**AGENDA**  
**City Planning Commission**  
**June 17, 2026, 5:30 PM**  
**Council Chambers – Hillsdale City Hall**

**Re: Consideration of Applications – 96 W Carleton Rd**

**Re:** Department Head Review – Commercial Site Plan

**Project:** PZ2026-017  
96 W CARLETON RD  
HILLSDALE, MI 49242  
NEW MULTI-TENANT COMMERCIAL BUILDING

Sheet No. C-5.0

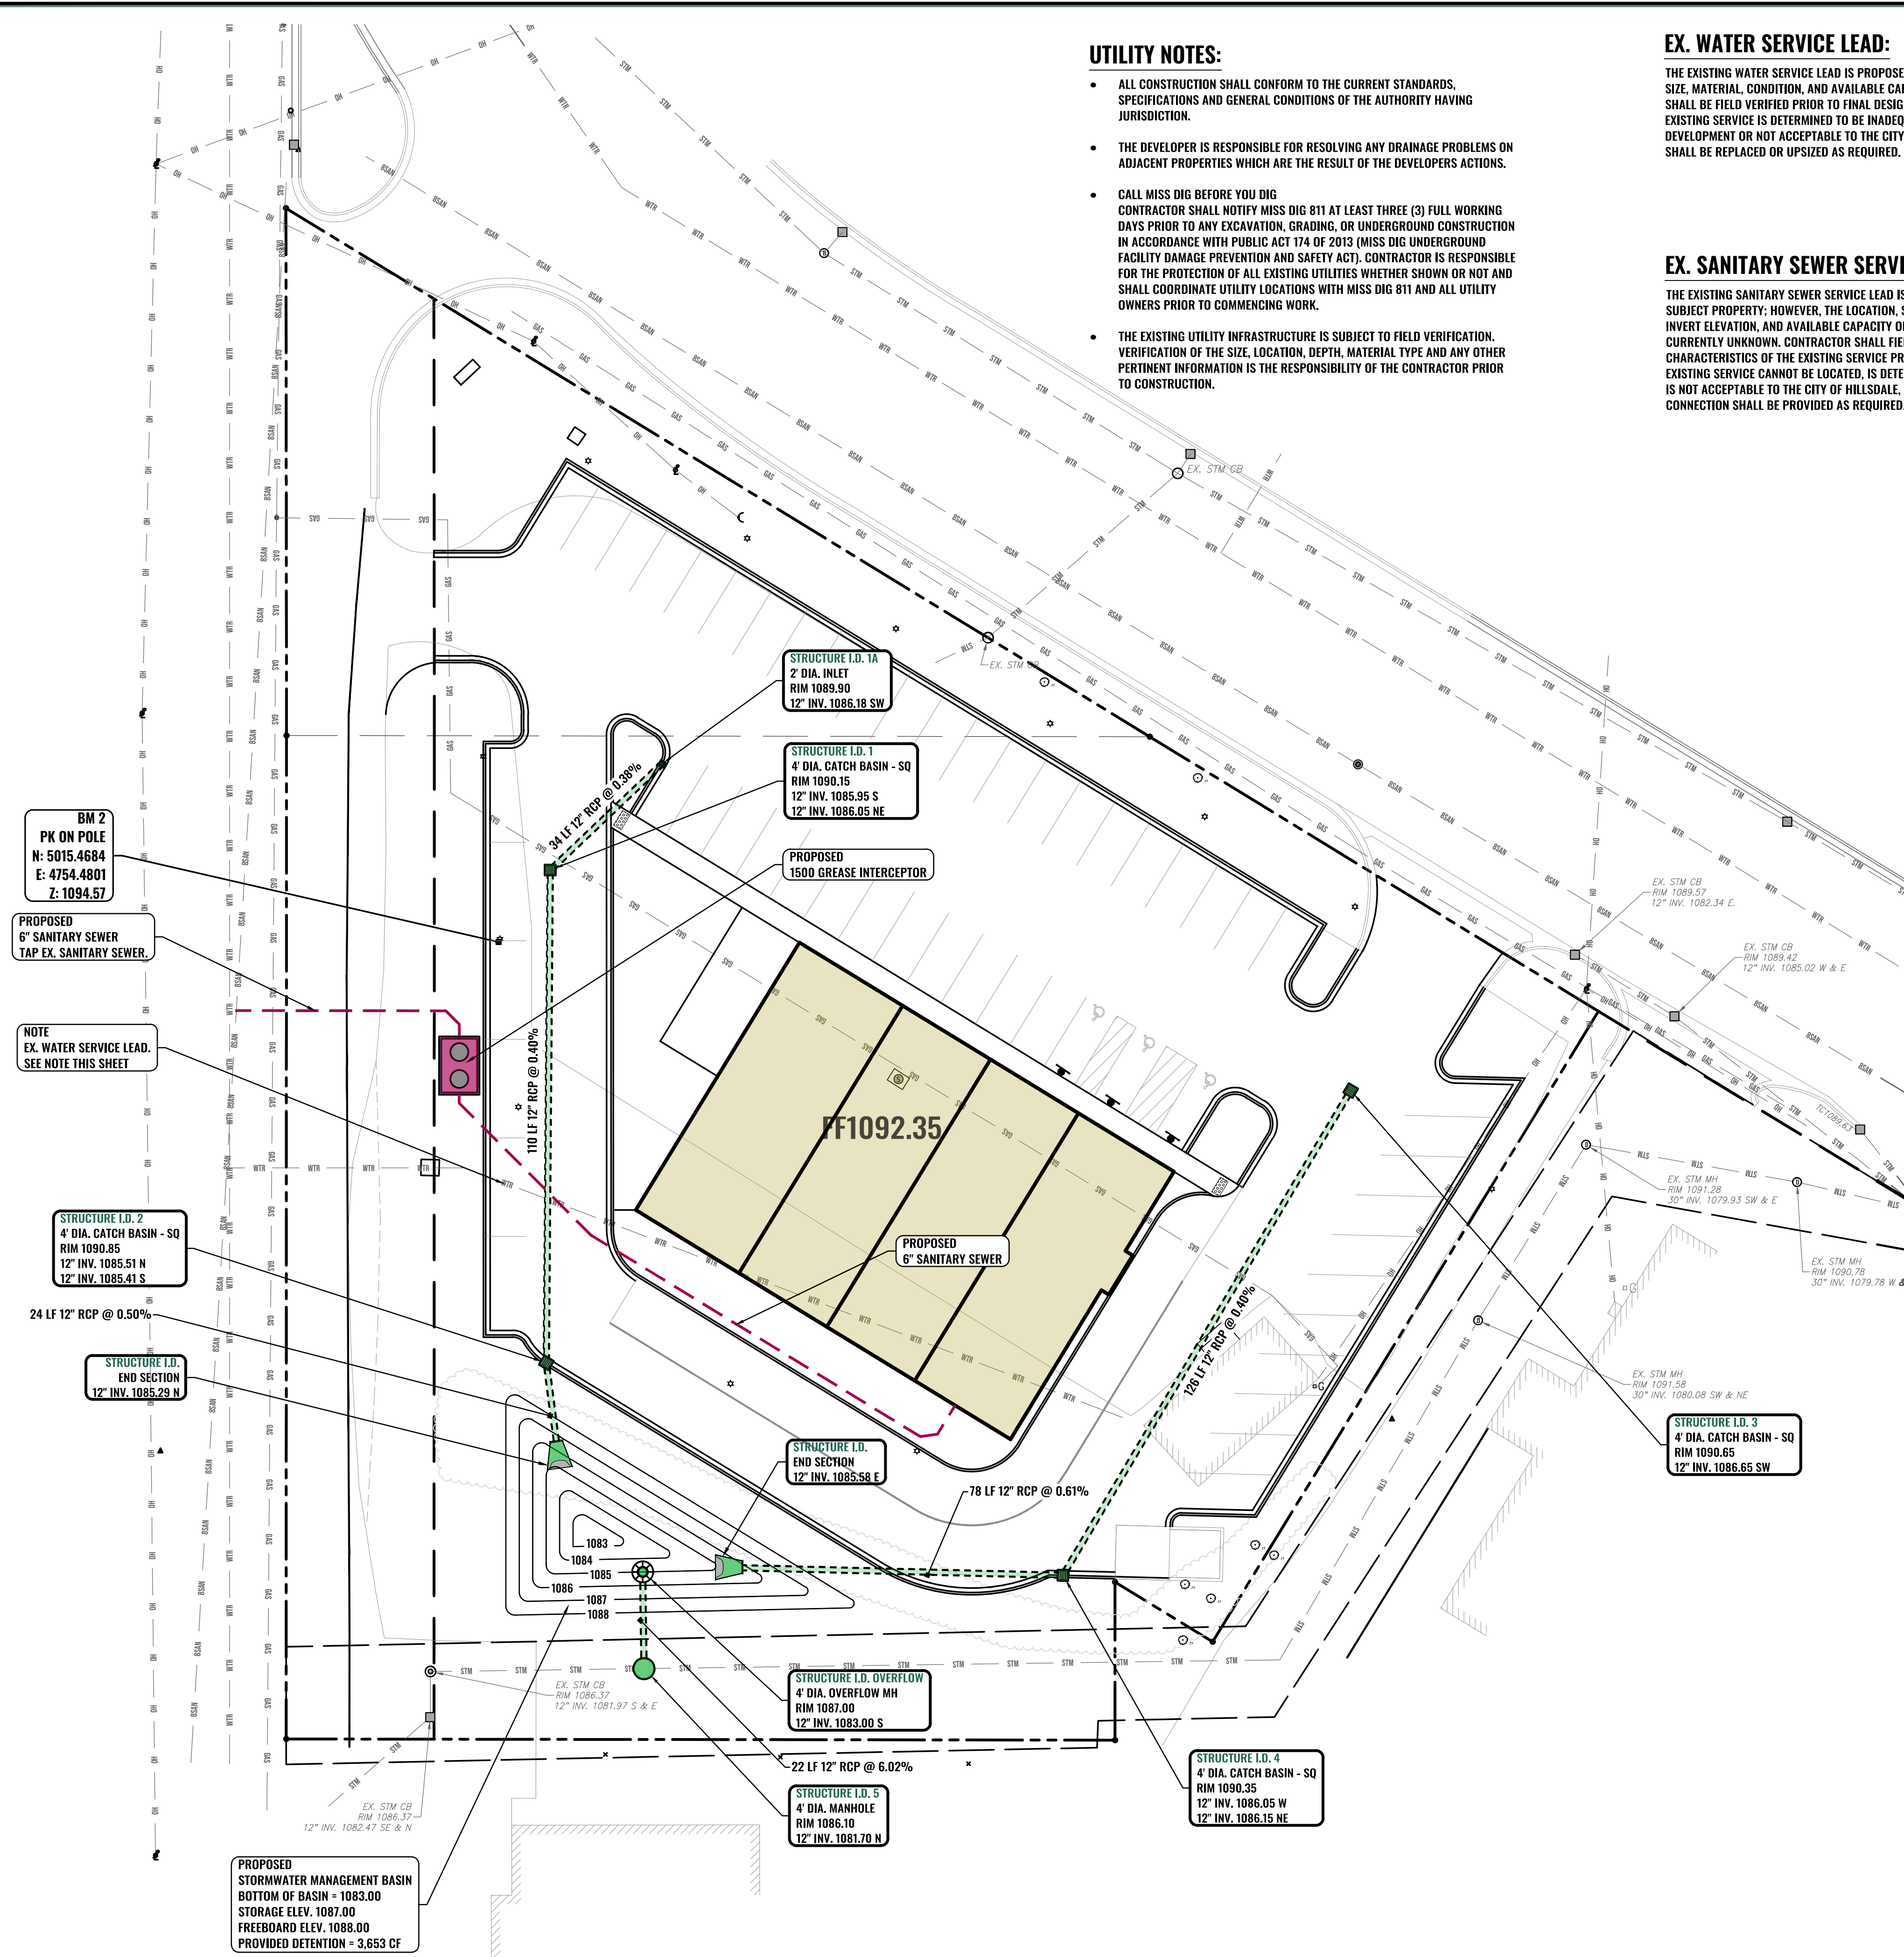
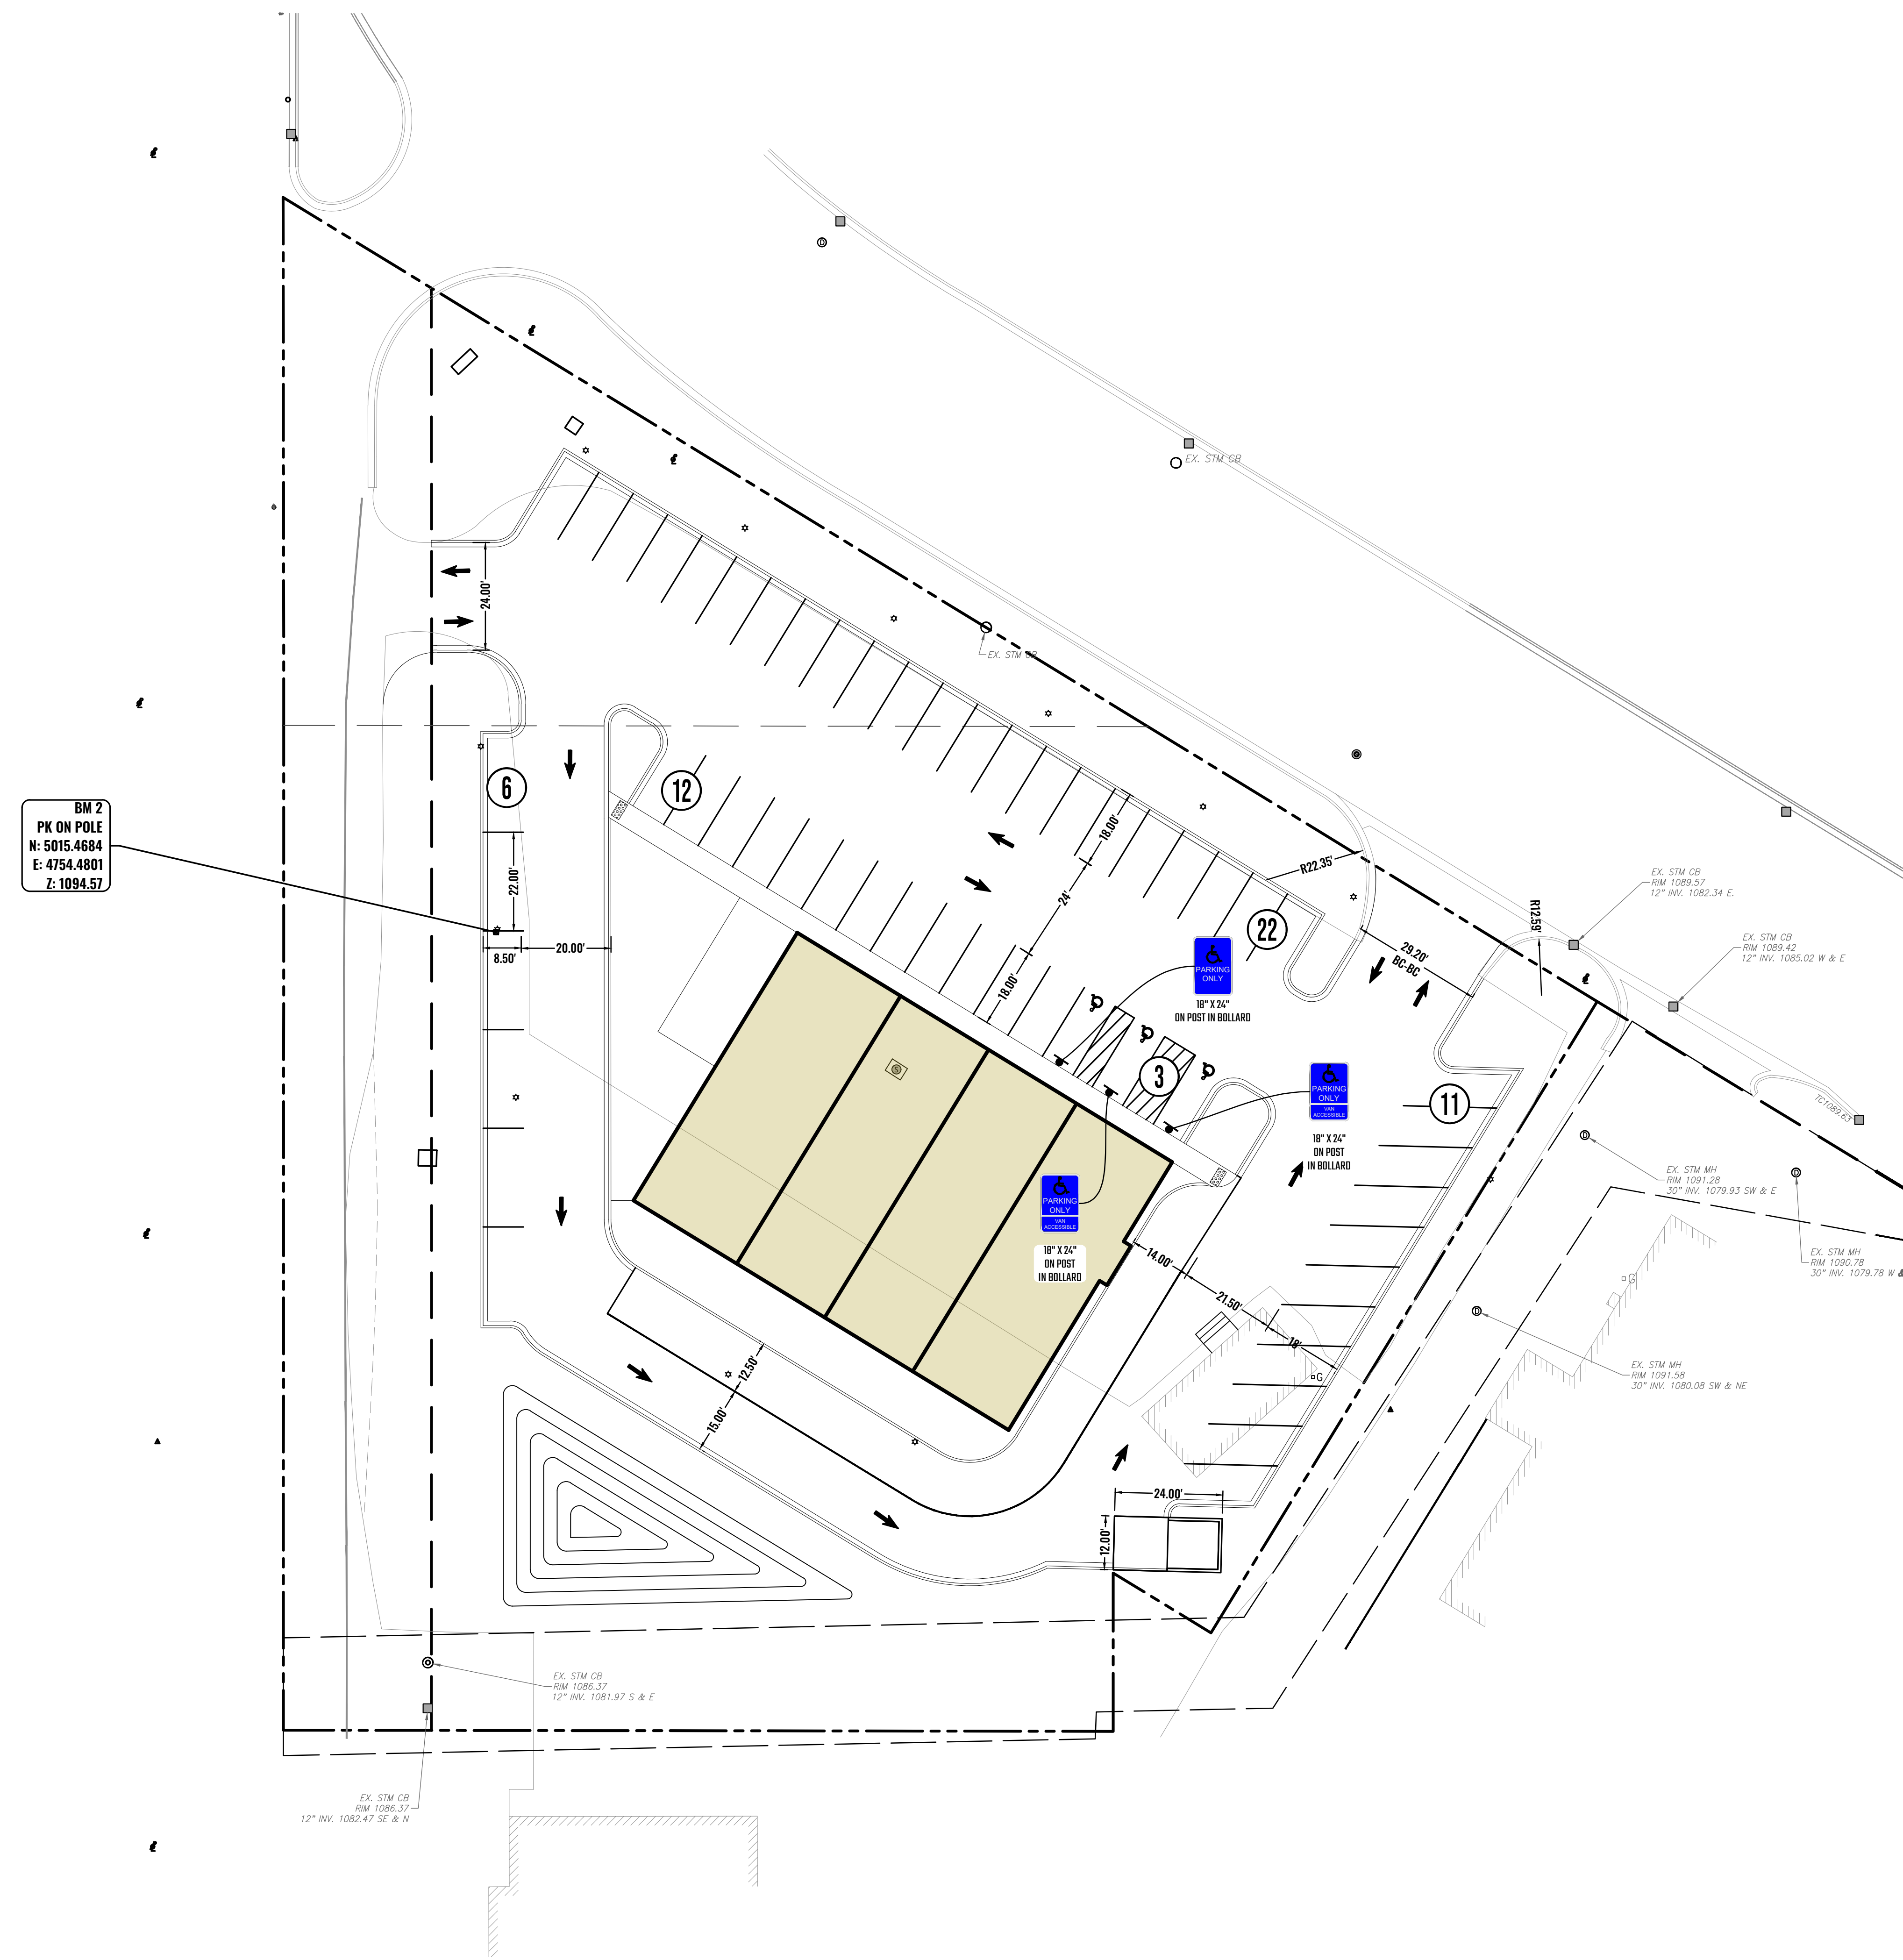
- Water and Sewer Department
  - **Did not see a list or drawing displaying any water or sewer specifications. There was not enough information provided for Staff to be able to comment.**

- **Provide calculations for the following:**
  - **Allowable Outflow**
  - **Design Outflow**
  - **Sizing of the restrictor**
  - **Details of the outlet control structure**
